Montgomery Planning

Agenda item I.A

Historic Area Work Permit

5419 Mohican Rd., Bethesda

Proposed Garage

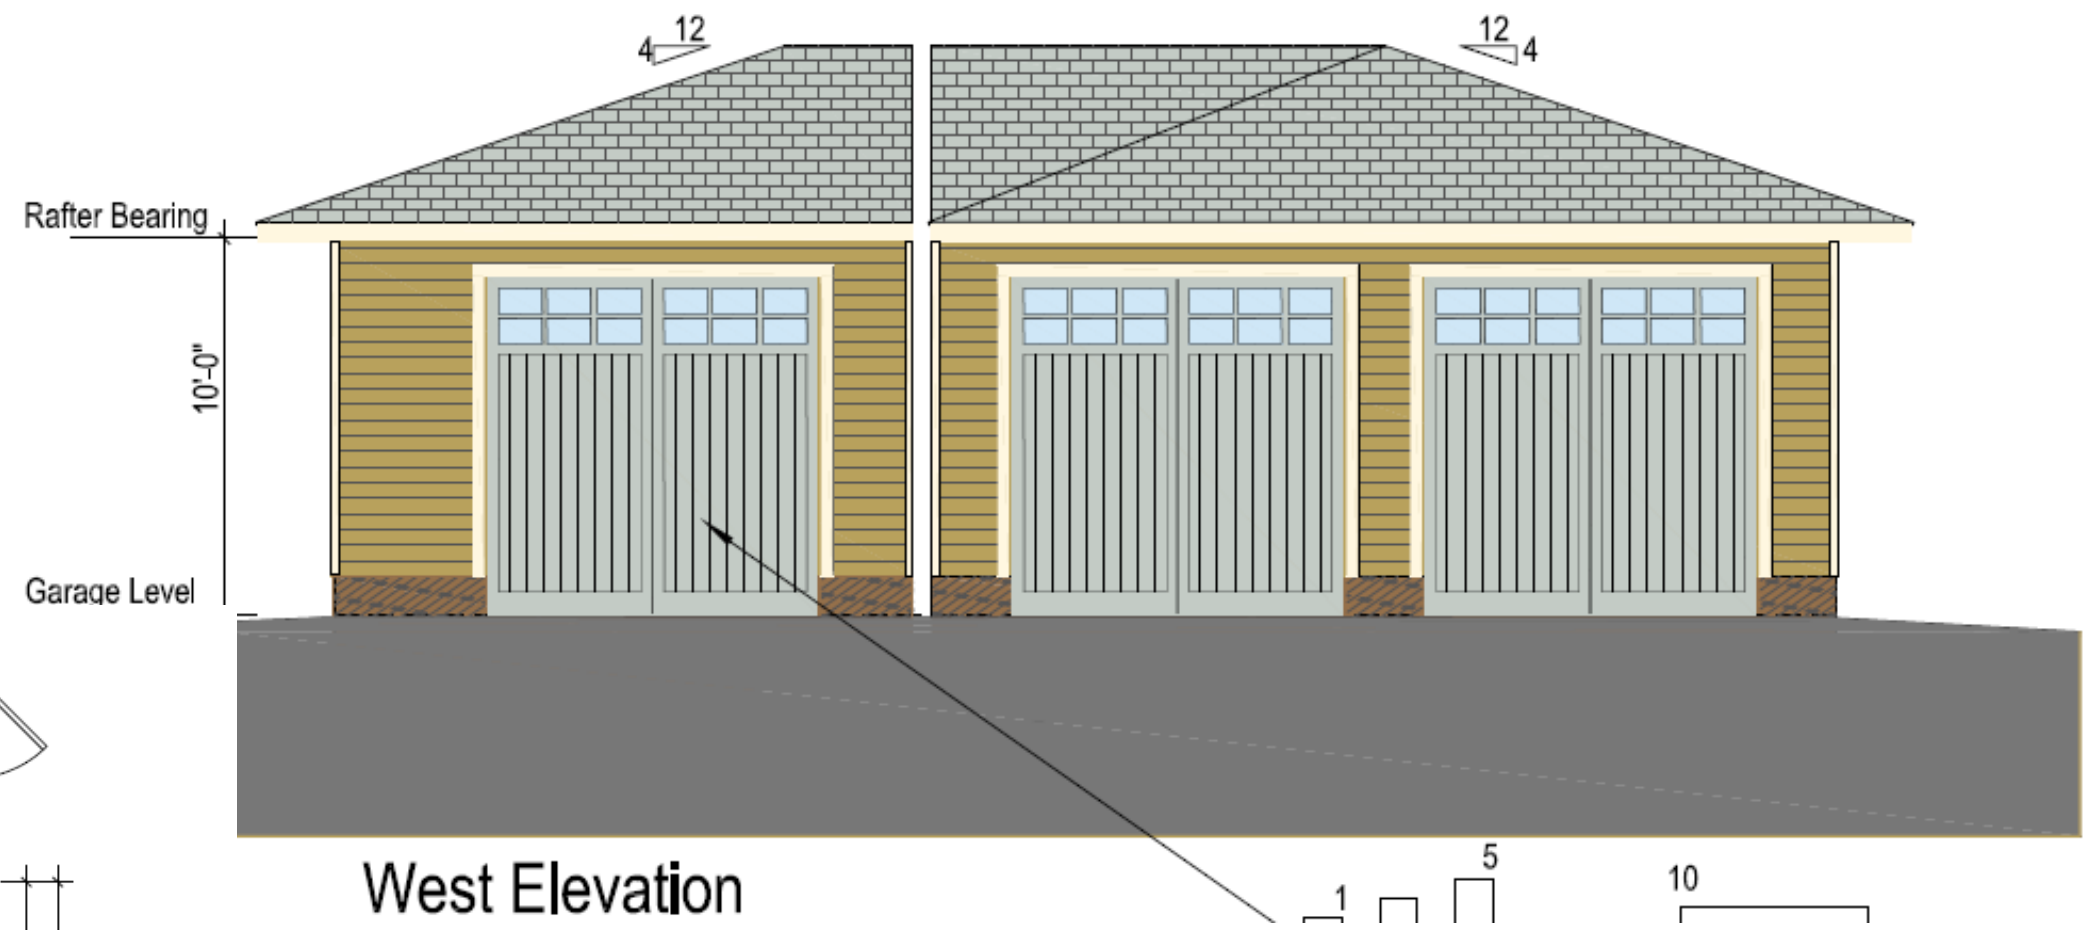
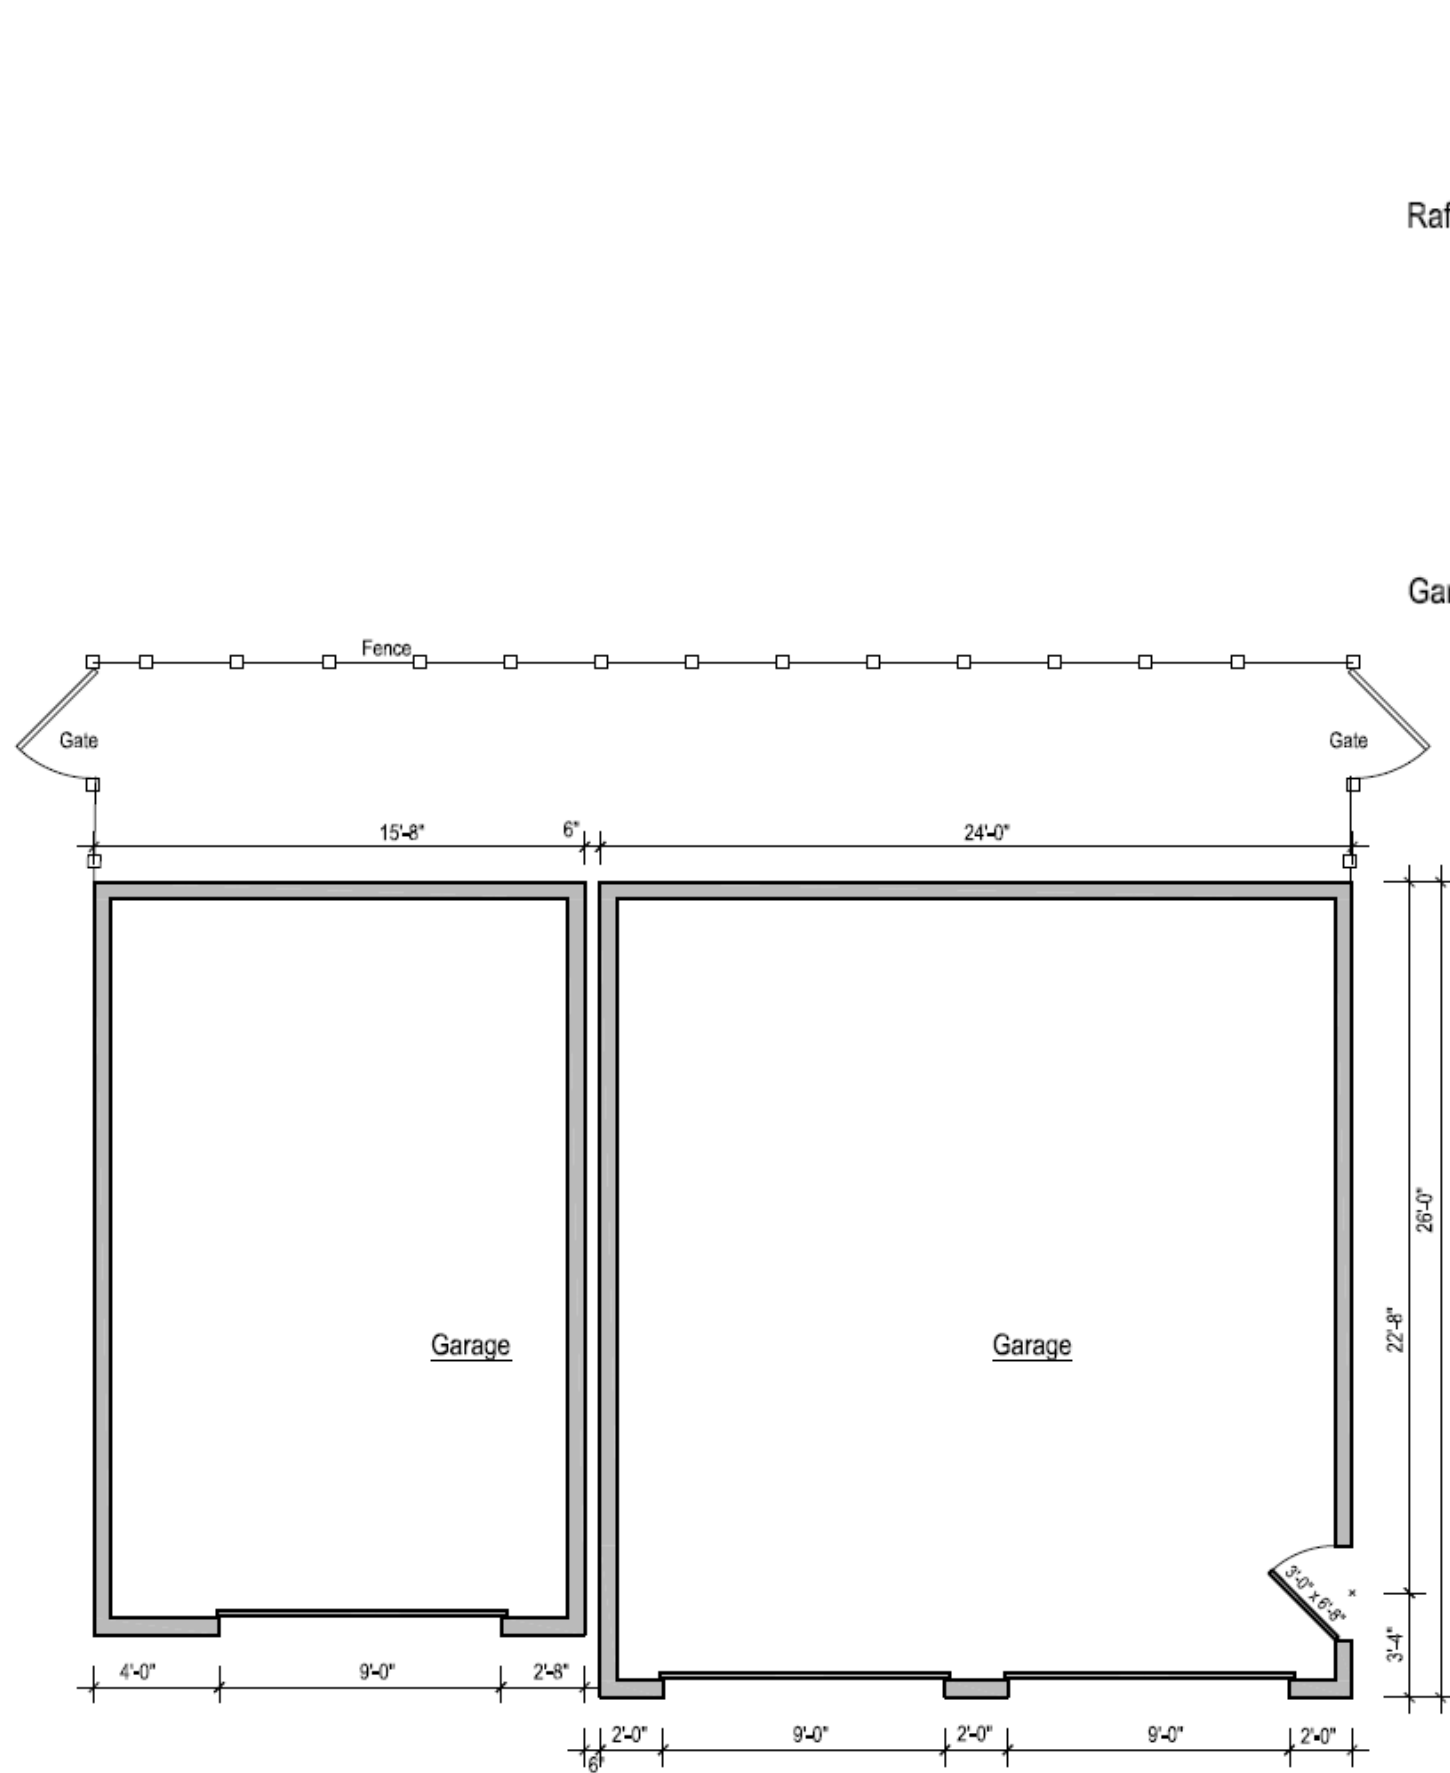
- At the prior Preliminary Consultations, the HPC provided guidance and recommendations to reduce the size and mass of the proposal.
 - A section of the roof was eliminated and turned into a virtually flat roof, which does result in a reduction in mass;
 - The width of the house has been reduced from 50' to 34'
- Typical infill construction requires the new to be subservient to the historic. Staff finds that a house larger than typically allowed can be compatible due to the site's development history and the long, narrow lot configuration.

- Staff finds the proposed location is appropriate for infill construction on the site.
- Staff finds that the Contemporary Craftsman design palate is appropriate for infill construction on the site.
- Staff finds the proposed materials (i.e. fiber cement siding, aluminum clad windows, architectural shingles, etc.) are compatible materials for infill construction on the site.
- Staff finds the massing has only seen minimal revisions.

- Staff finds that many of the design and massing revisions were made without consideration of the impact on the overall construction and have created an incongruous, incompatible architectural design and form.
- Staff finds the proposed house contravenes Standards 2 and 9 of the Secretary of Interior's Standards for Rehabilitation and recommends the HPC deny the proposed HAWP under 24A-8(a).
